ADDENDUM NO. 2
January 7, 2025

PROJECT: Metrorail Bathroom Rehabilitation

RPQ No: TP-0000027284
MCC 7360 Plan - CICC 7360-0/08

ADDENDUM NO.2

DOOR SCHEDULE

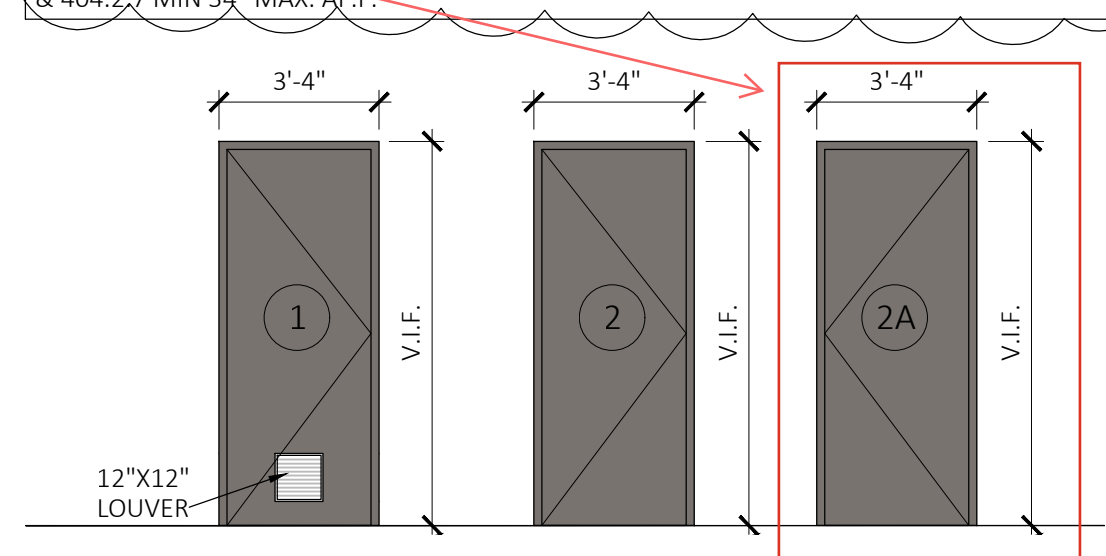
1. **Sheet A101, UHealth | Jackson Station - Engineering Drawings.** "Door Schedule"; the following information will be omitted: (See attached documents below as well)
 - a. **Door Schedule Table:** Delete any reference to Door 2A.
